TOWN CENTER NORTH & HAIGIS DISTRICTS CONCEPTUAL MASTER PLAN

FINAL REVISION | AUGUST 2020

RE: Conceptual Master Plan - Town Center North & Haigis Districts

5.0 COMMENT RESPONSES

PRELIMINARY INFRASTRUCTURE & PHASING PLAN

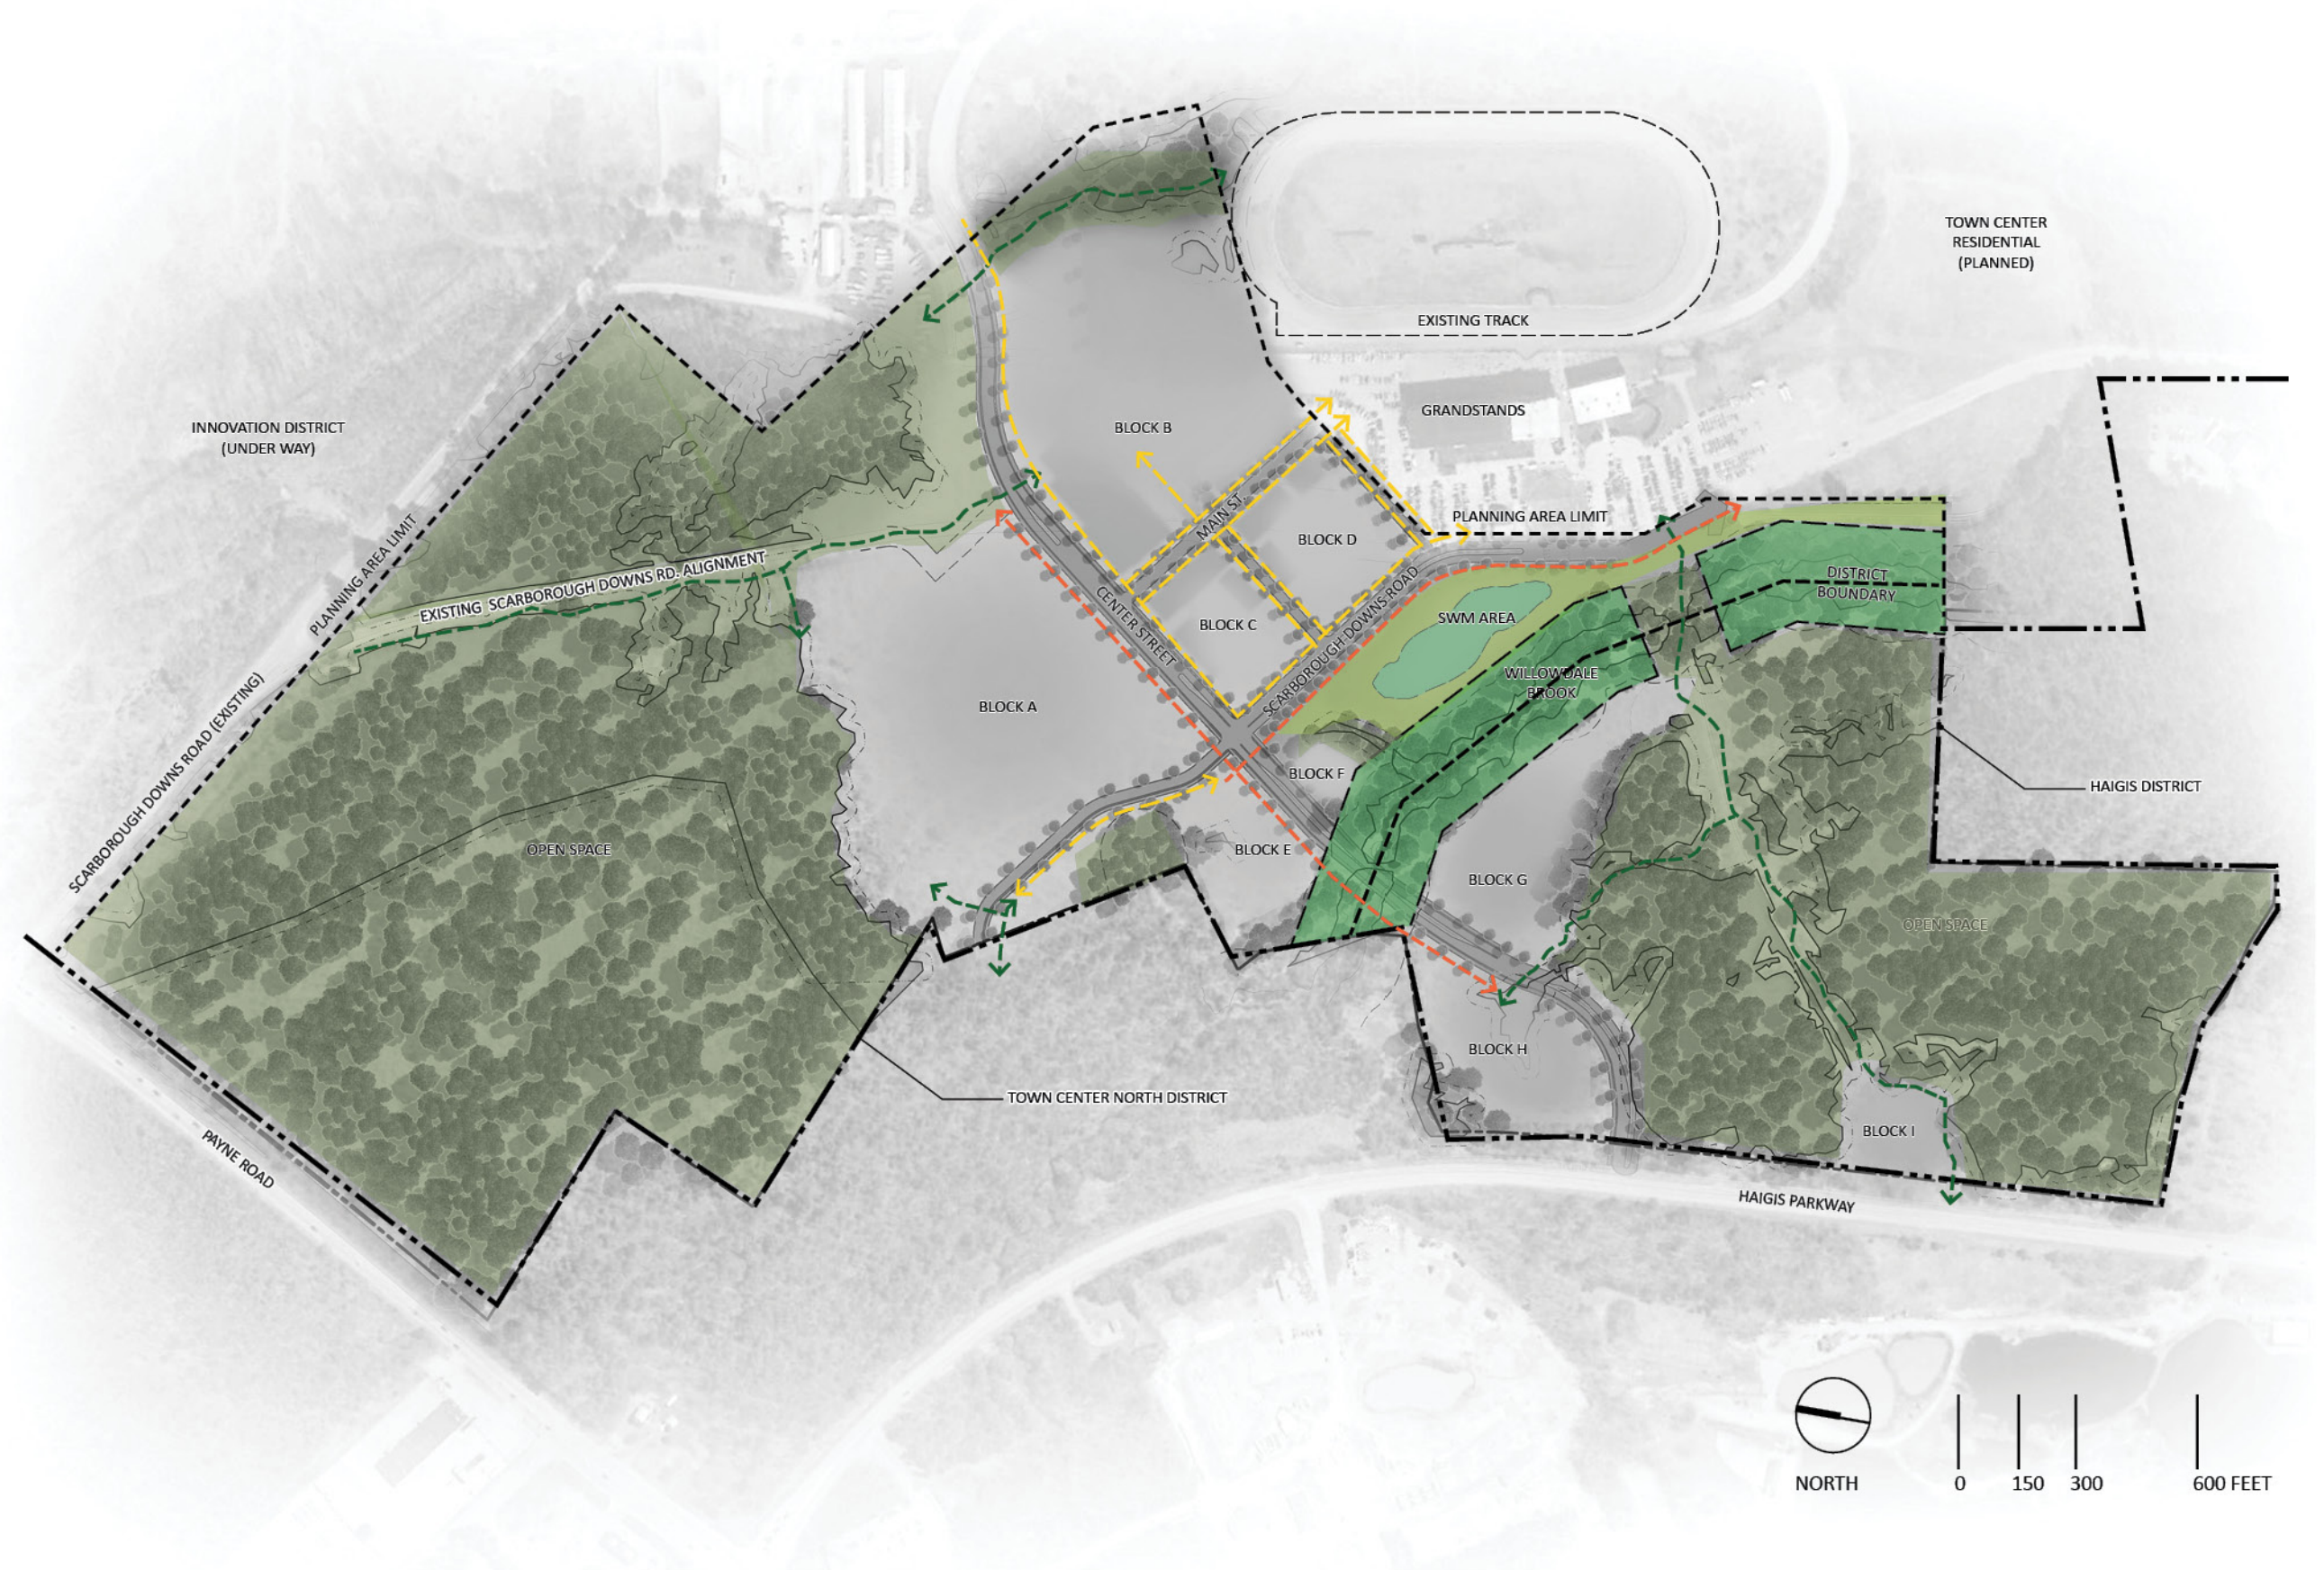
Section VII.E.E.2.c. Preliminary Infrastructure Plan (Planned Developments Ordinance). The preliminary infrastructure plan should be revised to include water and sewer utilities along the streets between Main Street and Scarborough Downs Road.

The plan continues to depict underground electric utilities transitioning to overhead electric along Center Street. As discussed with the Board, it is recommended that the electrical lines remain underground to the end of this phase along Block B toward the Innovation District.

Response: Water and sewer utilities have been included on the map where proposed.

Response: The applicant is actively evaluating feasibility for burying electric utilities along Block B and intends to address this issue further during subdivision review.

TYPICAL SITE PLAN & SECTION AT WILLOWDALE BROOK CORRIDOR AND DOWNS ROAD

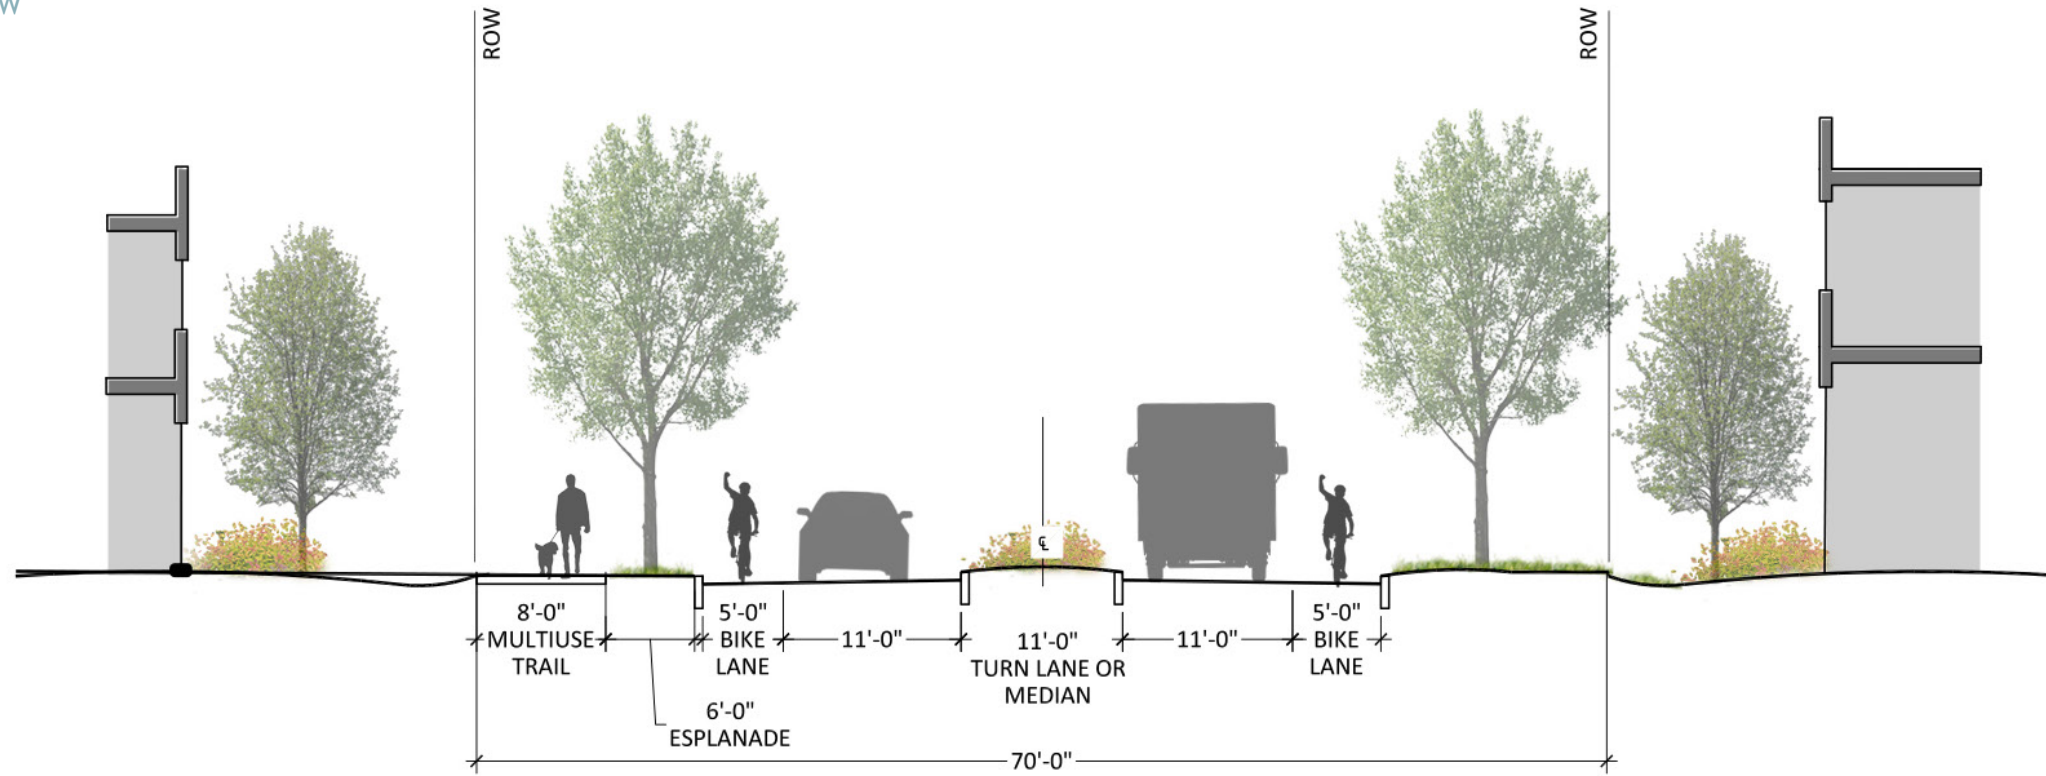
In the conceptual cross sections for Willowdale Brook Corridor, the left side of the easement appears to vary in length (65 feet to 90 feet). The plans also appear to depict stormwater BMPs, proposed grading, and placemaking features within the protected corridor. The applicant should provide details related to what is being proposed within the protected Willowdale corridor.

Response: The applicant intends to limit impacts within the protected corridor. The illustrative section indicates potential BMP's and placemaking program outside the conservation easement boundaries.

MAIN STREET(S) (SECONDARY) 60-70' ROW

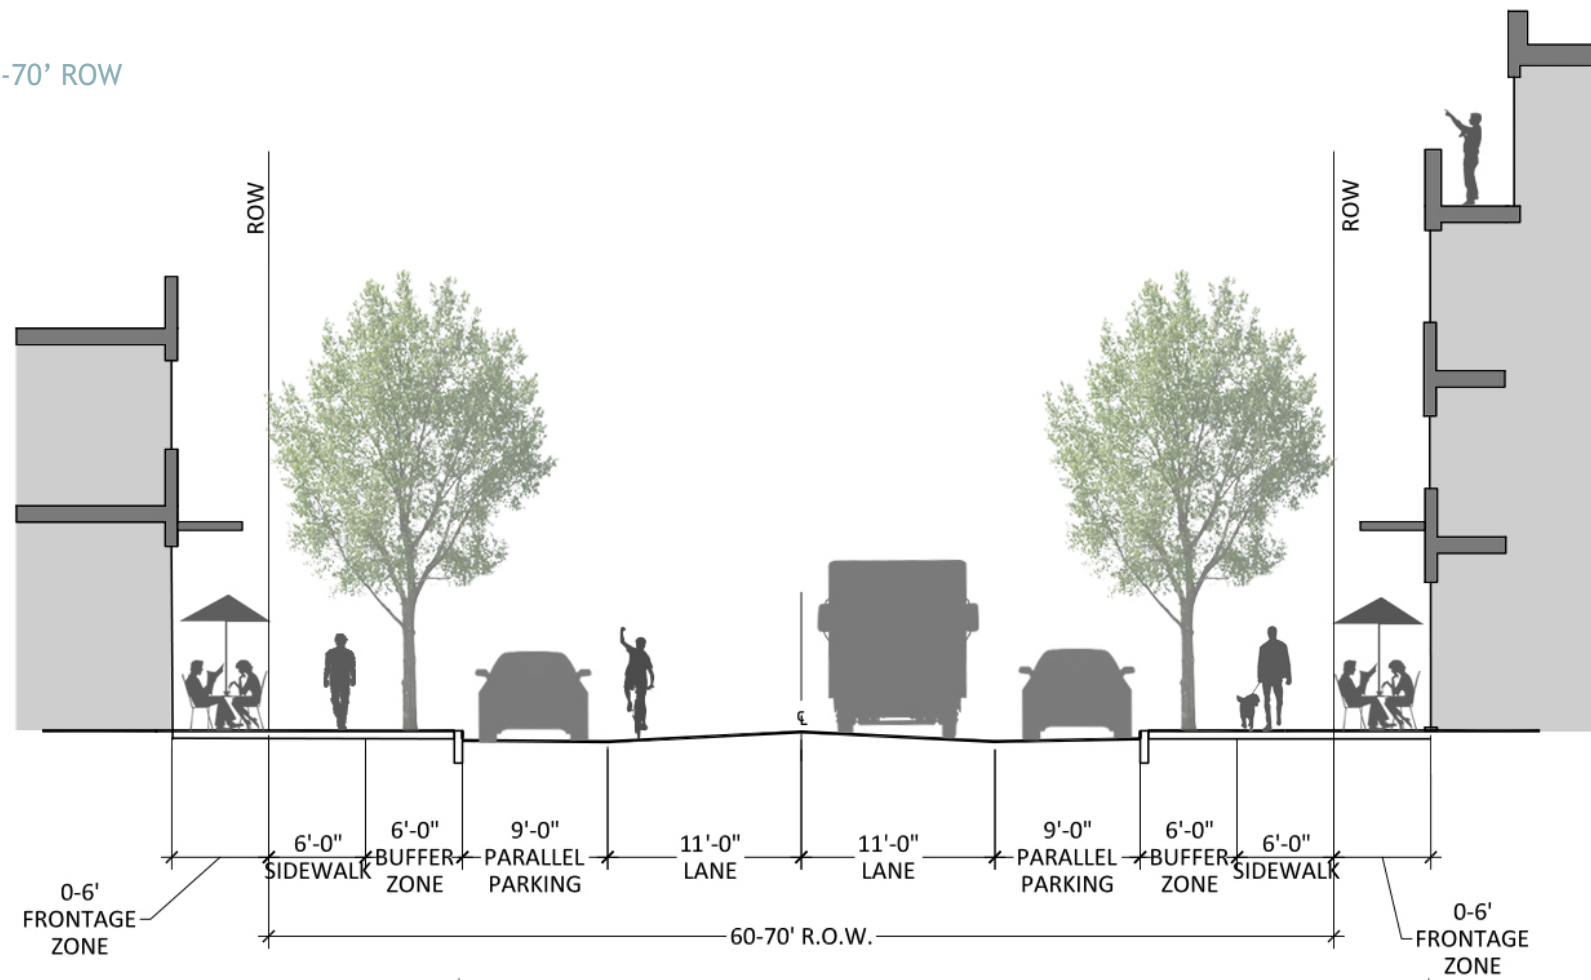
The concept depicted on the “Main/Market Street(s)” street cross-section of the wide amenity zone that can be actively utilized by business customers as well as passerby appears to be in keeping and promoting the vibrancy sought by the zoning. While the proposed 18-foot (+/-) of the area would appear to enable full functionality, staff does question if the proposed 6-foot wide privately-owned amenity zone would actually enable functional usage of restaurant seating and other outdoor uses as depicted. The private / public interplay at the edge of the “Main/Market Street” right-of-way remains a question that will need to further reviewed and considered as this project moves forward to subdivision review.

Response: The applicant will address this issue during subdivision review.

TERTIARY STREET 60' ROW

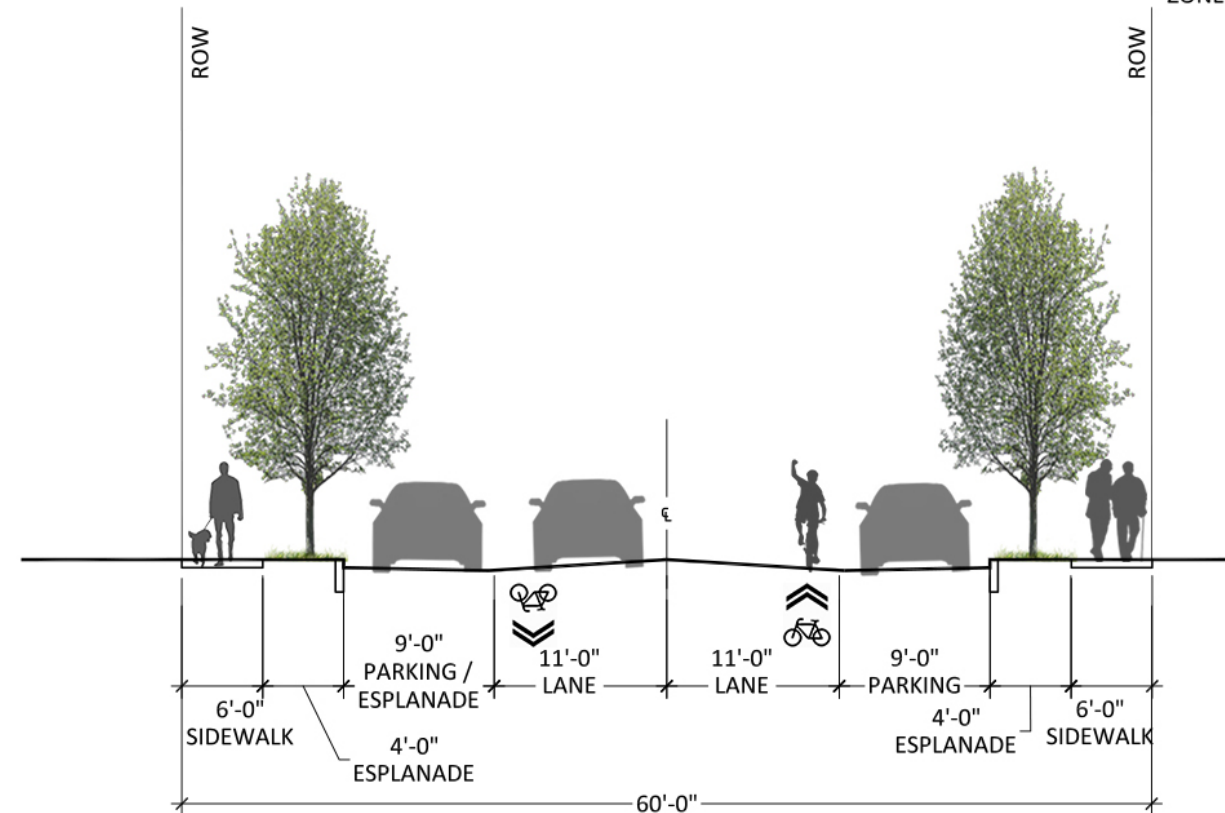
Staff would like to note that sidewalks are recommended to be a minimum of 5-1/2-feet wide if being measured from face of curb to allow ample room for future sidewalk plowing operations. The proposed sidewalks depicted on the “Tertiary Street” cross-section should be revised accordingly. Also, it was noted during the last workshop that the buildings along these streets would most likely be located at the right-of-way line and therefore, it should also be noted that any mechanical or utility service equipment will be required to be outside of the future public right-of-way.

Response: The 'Tertiary Street' cross-section has been revised to reflect a 6' width sidewalk and 4' esplanade.
